Vehicle Impact (7154)

IFC: 1207.11.7, 1207.11.7.1 (New), 1207.11.7.2 (New), 1207.11.7.3 (New), 1207.11.7.3.1 (New), 1207.11.7.3.2 (New), 1207.11.7.3.3 (New), Figure 1207.11.7.1 (New), Figure 1207.11.7.3 (New)

2021 International Fire Code

Figure 1207.11.7.3
Impact Protection Options

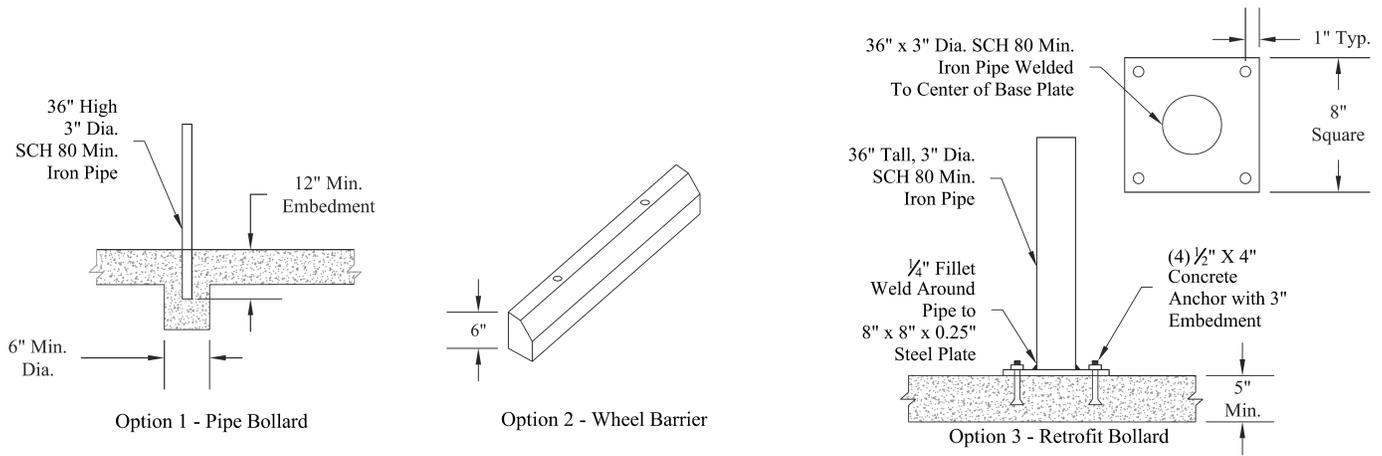
1207.11.7.3 Impact Protection Options Where the ESS is in the normal driving path of vehicle travel, one of the following methods shall be used. (See Figure 1207.11.7.3)

1207.11.7.3.1 Bollards Bollard construction shall comply with one of the following:

1. 48 in. L x 3 in. Dia. (1219 mm x 76 mm) SCH. 80 steel pipe embedded in a concrete pier 12 in. (304 mm) deep and 6 in. (152 mm) diameter, with 36 in. (914 mm) of pipe exposed, filled with concrete, and spaced at a maximum interval of 60 in. (1524 mm) Each bollard shall be located not less than 6 in. (152 mm) from an ESS.

2. 36 in. H x 3 in. (914 mm x 76 mm) Dia. SCH. 80 steel pipe fully welded to an 8 in. x 8 in. x ¼ in. (203 mm x 203 mm x 6.4 mm) thick steel plate and bolted to a concrete floor by means of (4) ½ in. (13 mm) concrete anchors with 3 in. (76 mm) minimum embedment. Spacing shall be 60 in. (1524 mm) maximum, and each bollard shall be located not less than 6 in. (152 mm) from the ESS.

3. Pre-manufactured steel pipe bollards shall be filled with concrete and anchored in accordance with the manufacturer's installation instructions, 60 in. maximum spacing. Located not less than 6 in. (152mm) from the ESS.

1207.11.7.3.2 Wheel barriers Wheel barrier construction shall comply with one of the following:

-
1. 6" H x 6" W (152 mm x 152 mm) wheel barrier made of concrete or polymer, anchored to the concrete floor every 36 in. (914 mm) minimum and located not less than 54 in. (1372 mm) from the ESS.. Minimum (2) ½ in. (13 mm) diameter concrete anchors with 3 in. (76 mm) embedment per barrier shall be used. Spacing between barriers shall be a maximum of 36 in. (914 mm).

2. Pre-manufactured wheel barriers shall be anchored in accordance with the manufacturers installation instructions.

1207.11.7.3.3 Other Methods

1. Approved method designed to resist a 2000 lb impact in the direction of travel at 24 in. above grade.
